STAFF RECOMMENDATION
3926 Cambridge Avenue
August 16, 2017

Application: New construction—addition and outbuilding
District: Cherokee Park Neighborhood Conservation Zoning Overlay
Council District: 24
Map and Parcel Number: 10308018400
Applicant: Van Pond, Jr.
Project Lead: Melissa Sajid, melissa.sajid@nashville.gov

Description of Project: Application is to construct an addition that is taller and wider than the historic house. Application is also to construct an outbuilding. The outbuilding will not contain a dwelling unit. **Recommendation Summary:** Staff recommends disapproval of the addition finding that that the addition's height, scale, and roof form do not meet the design guidelines. Staff finds that the addition does not meet Sections II.B.1.a, II.B.1.b, II.B.1.e, and II.B.2. of the Cherokee Park Neighborhood Conservation Zoning Overlay design guidelines. Staff recommends approval of the outbuilding with the condition that staff approve the materials of the windows, doors, and roof color prior to purchase and installation, finding that the outbuilding meets Section II.B.1.h of the design guidelines. *The Commission does not have the authority to approve the use. This reco

DATE OF ISSUANCE:
1 July 2017
REVISED: 2 August 2017
PROPOSED SITE PLAN

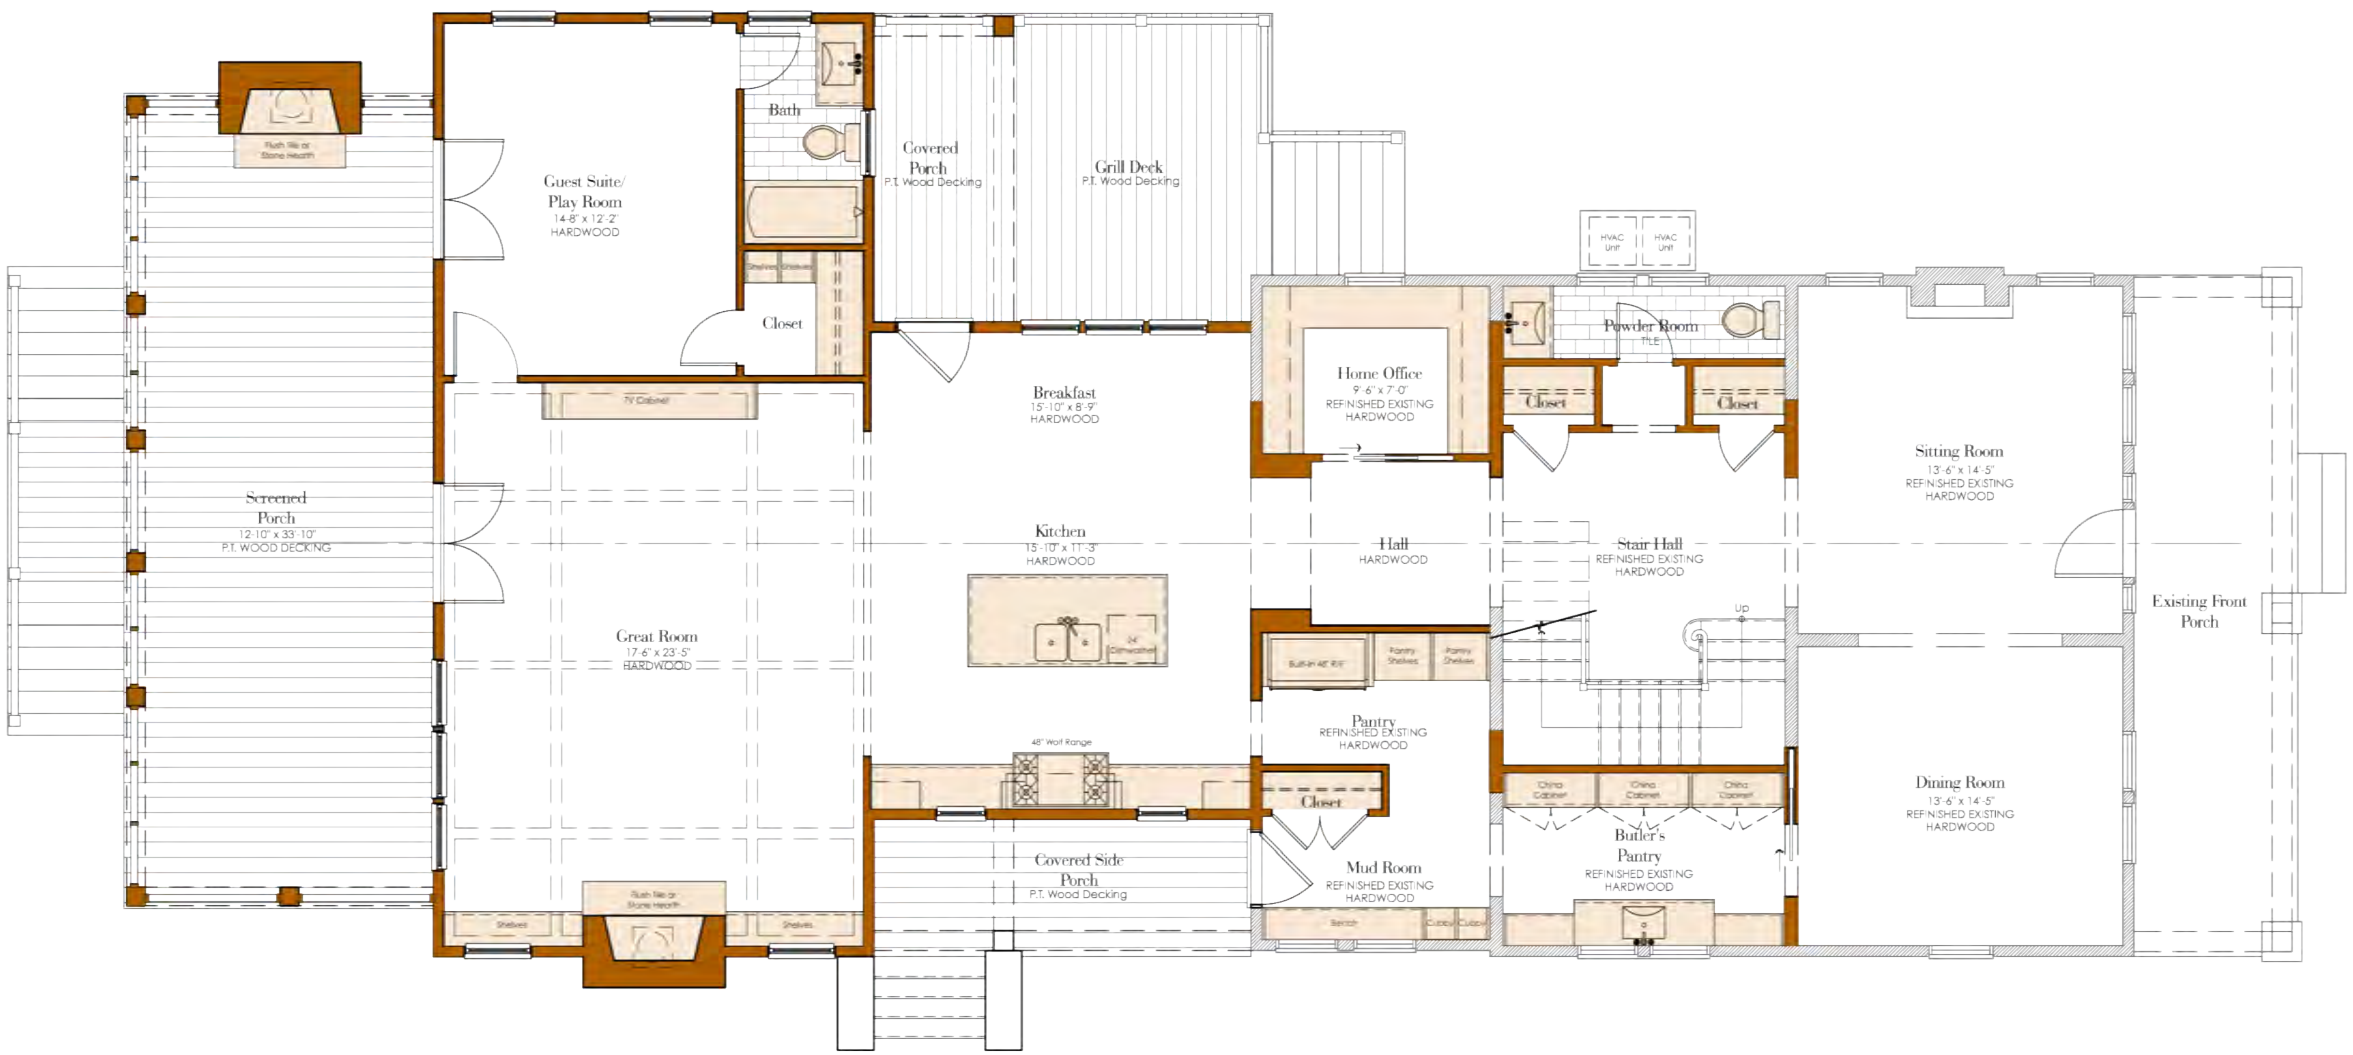
The footprint of the addition will more than double the footprint of the historic house. The footprint of the historic house is approximately one thousand, two hundred, and seventy-five square feet (1,275 sq. ft.), including the front covered porch, and is approximately forty-two feet (42') deep. The proposed addition, including all of the covered entries and screened porches, has a footprint of approximately one thousand, six hundred, and twenty square feet (1,620 sq. ft.) and increases the depth of the house by approximately forty-five feet (45'). Staff finds that the slightly larger footprint could be appropriate since the house is relatively small in scale and is on a lot that is nearly sixteen thousand square feet (16,000 sq. ft.). The site plan shows that the lot is encumbered with a twenty foot (20') wide public sewer easement that abuts the proposed rear addition; however, that easement begins approximately 150' from the front property line which is a typical lot depth and there is adequate space on the other side of the easement for an outbuilding. In this case, Staff did not find the easement to be an unusual condition.

Setback: The addition meets all base zoning setbacks. It will be five feet (5') from the right-side property line and approximately fifteen feet (15') from the left-side property line. It will be over one hundred and twenty feet (120') from the rear property line. While the wider and taller portions of the addition will not be as highly visible from the street as with the previous version of the plan, they will still be visible with this revised plan. Staff finds that the addition's setback and rhythm of spacing meet Sections II.B.1.c. and II.B.2. of the design guidelines.

DATE OF ISSUANCE:
1 July 2017
REVISED: 2 August 2017
DETACHED GARAGE PLANS

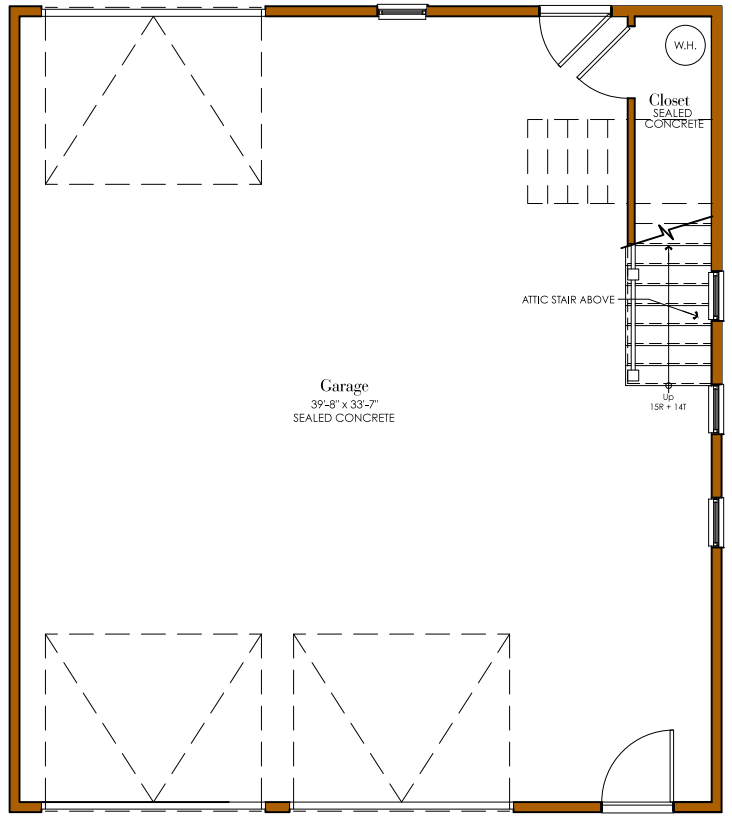
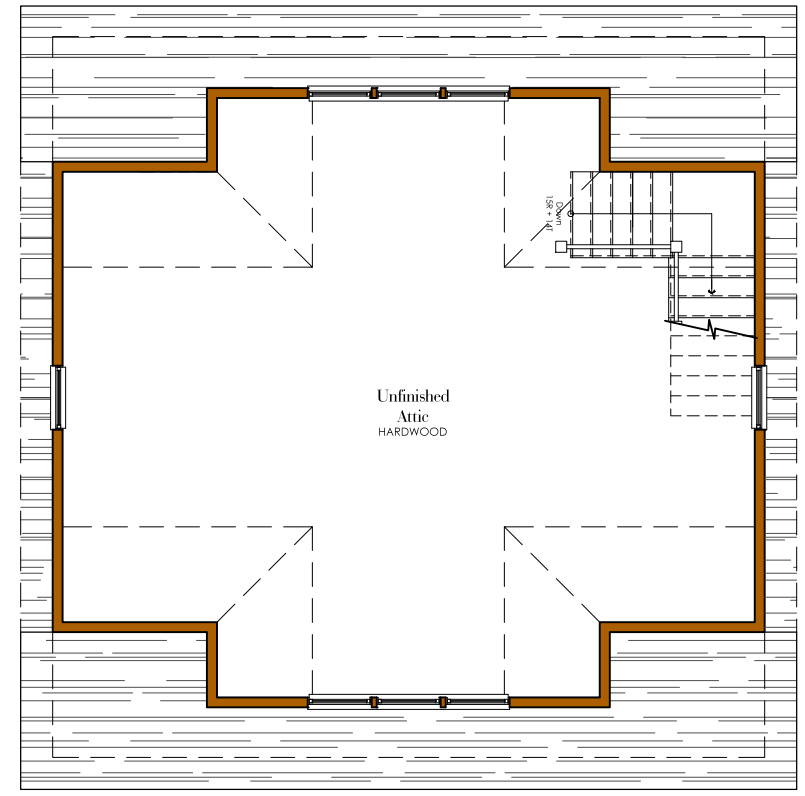
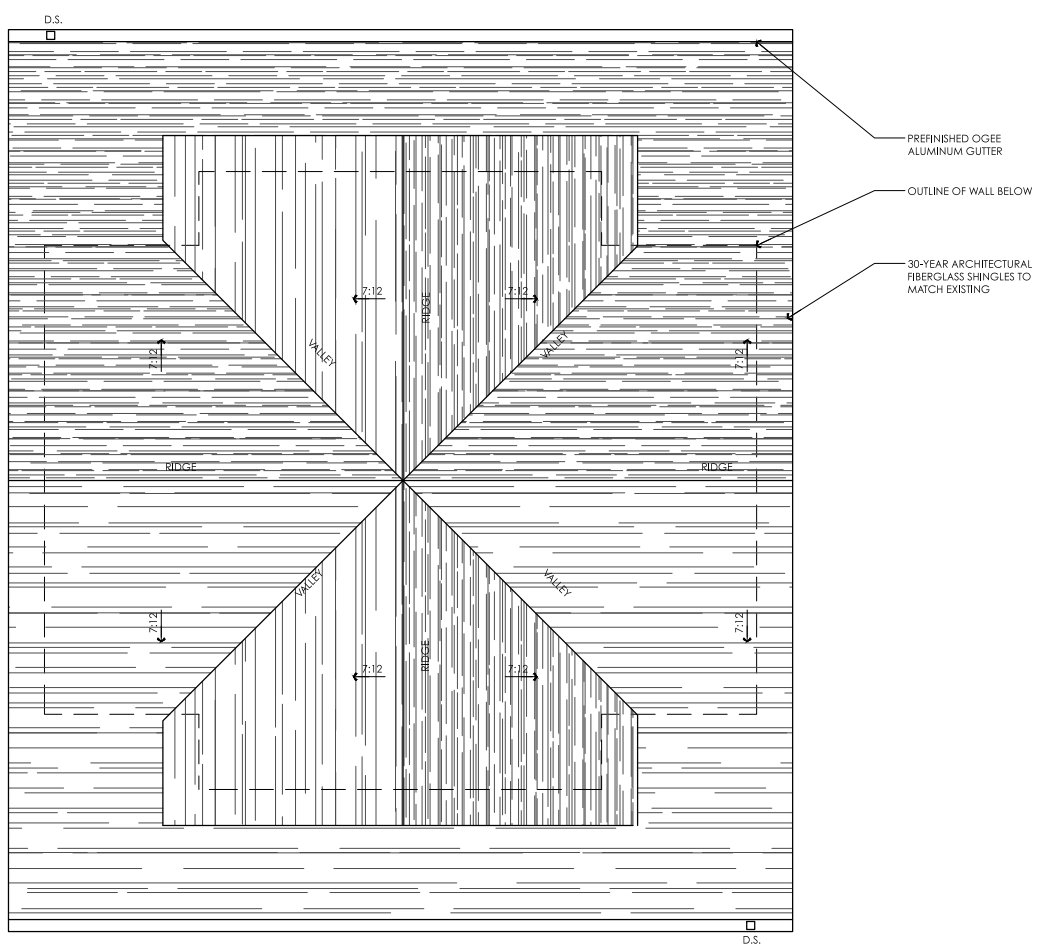
Massing Planning: The proposed is a one-and-half story building on a lot more than 10,000 square feet.

Potential maximums (heights to be measured from grade)	Existing conditions (height of historic portion of the home to be measured from finished floor)	Proposed
Ridge Height	25’ unless existing building is less	20’	19’-10”
Eave Height	10’	11’	10’

Proposed	50% of first floor area of principle structure	Lot is more than 10,000 square feet	Proposed
Maximum Square Footage	≈1,380 sq. ft.	1,000 sq. ft.	996 sq. ft.

Staff finds that the outbuilding's massing meets Section II.B.h.1 of the design guidelines

Staff recommends approval of the outbuilding with the condition that staff approve the materials of the windows, doors, and roof color prior to purchase and installation, finding that the outbuilding meets Section II.B.1.h of the design guidelines.

1 South Elevation (Cambridge Avenue)

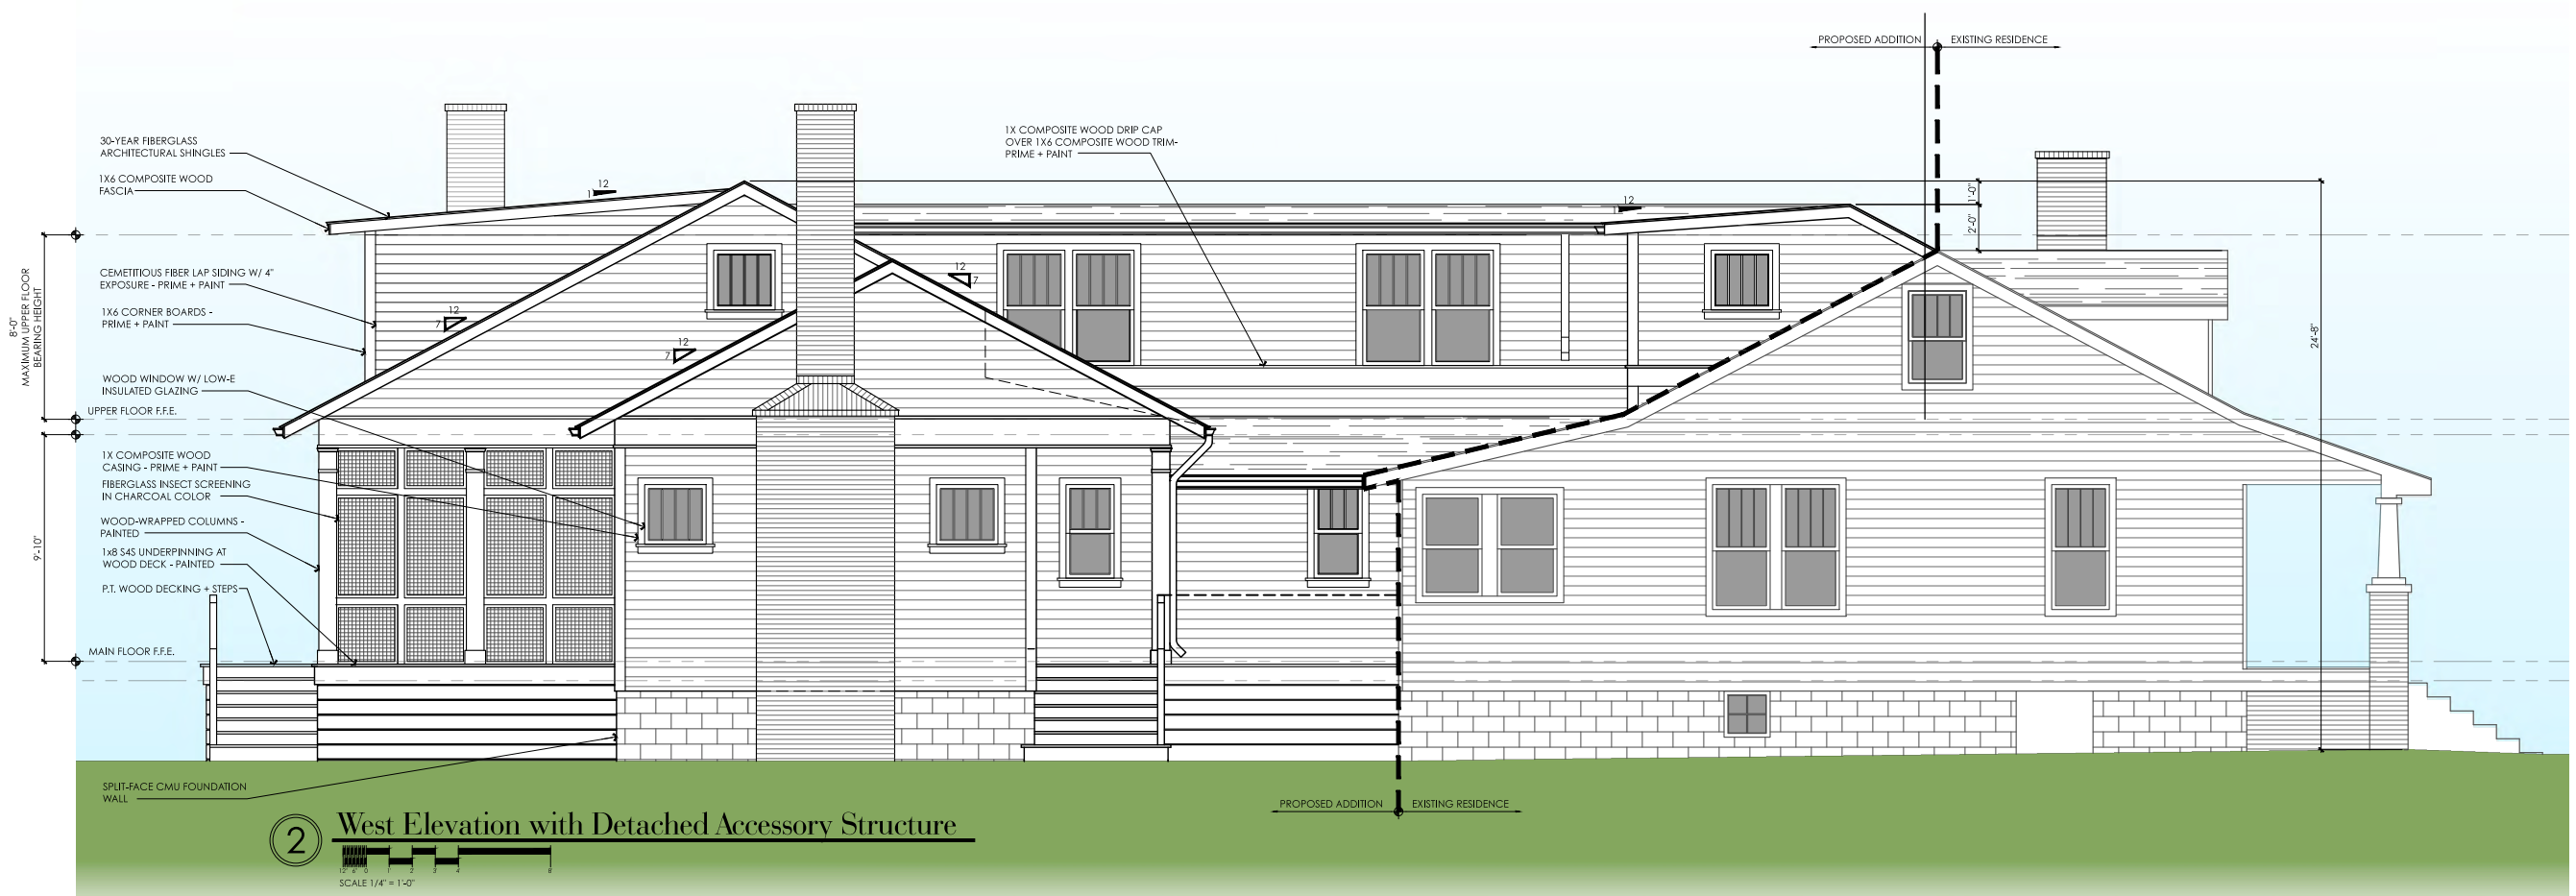
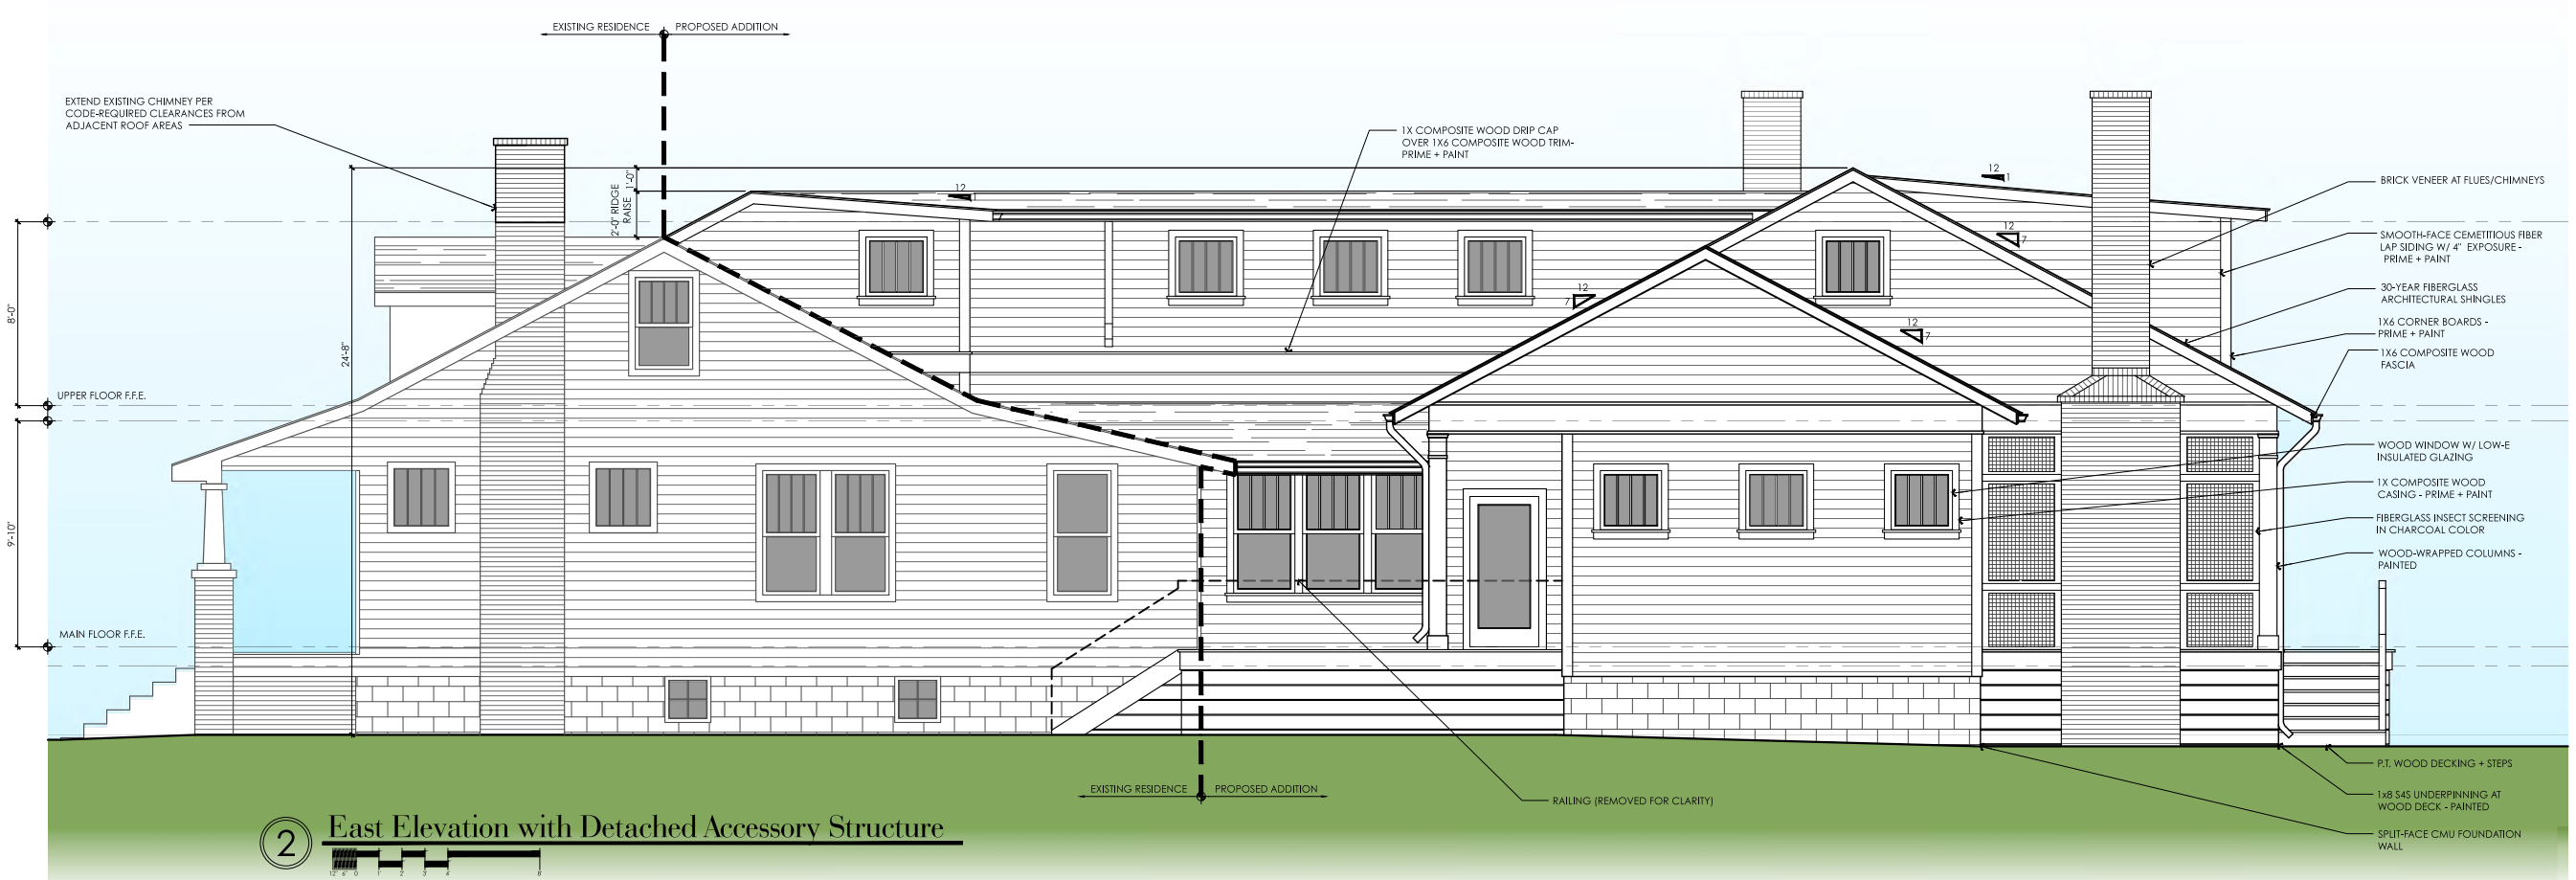
<u>Height & Scale</u>: The proposed addition includes a ridge raise. The ridge raise will e inset two feet (2’) from the side walls of the historic house, which meets the design

guidelines and will increase the roof by two feet (2') vertically. The addition will the rise an additional foot (1') approximately forty-six feet (46') beyond the ridge raise, for a total additional height of three feet (3'). The design guidelines state that "*The purpose of a ridge raise is to allow for conditioned space in the attic and to discourage large rear or side additions. The raised portion must sit in a minimum of 2' from each side wall and can be raised no more than 2' of total vertical height within the same plane as the front roof slope."* While the ridge raise no longer exceeds the maximum additional height of two feet (2'), staff finds that the height of the addition should be limited to the two feet (2') ridge raise to help meet the design guidelines stated purpose for the ridge raise, which is to discourage large rear or side additions.

The rear addition will be both taller and wider than the historic house. An addition that is wider than the historic house could be appropriate in this instance because the lot is sixty feet (60') wide and because the house is relatively narrow at just twenty-nine feet (29'). However, the design guidelines state that "*In these cases, an addition may rise above <u>or</u> extend wider than the existing building; however, generally the addition should not higher <u>and</u> extend wider."* Staff finds the portion of the addition that is eight feet, eleven inches (8'-11") wider than the historic house and three feet (3') taller than the historic house to be inappropriate. In addition, an addition that is both taller and wider does not meet the stated purpose of the ridge raise.

Design: The addition's change in materials and inset help to distinguish it from the historic house and read as an addition to the house. However, the addition's height and scale and tall ridge raise are not compatible with the historic character of the existing house. Staff finds that the addition does not meet Sections II.B.2.a and II.B.2.f. of the design guidelines.

Roof form: The addition is side-gabled with pitches that complement the roof form of the historic house. As discussed under "Height and Scale," the proposed ridge raise on the revised plan meets the design guidelines because it increases the height of the roof by no more than two feet (2') vertically; however, staff finds that the additional foot (1') of height proposed does not meet the design guidelines as it does not help to discourage a large rear or side addition, which is the stated purpose for the ridge raise per the design guidelines. Staff finds that the ridge raise combined with the additional foot (1') of height and large footprint does not meet Sections II.B.1.e. and II.B.2. of the design guidelines.

Recommendation Summary: Staff recommends disapproval of the addition finding that that the addition's height, scale, and roof form do not meet the design guidelines. Staff finds that the addition does not meet Sections II.B.1.a, II.B.1.b, II.B.1.e, and II.B.2. of the Cherokee Park Neighborhood Conservation Zoning Overlay design guidelines.
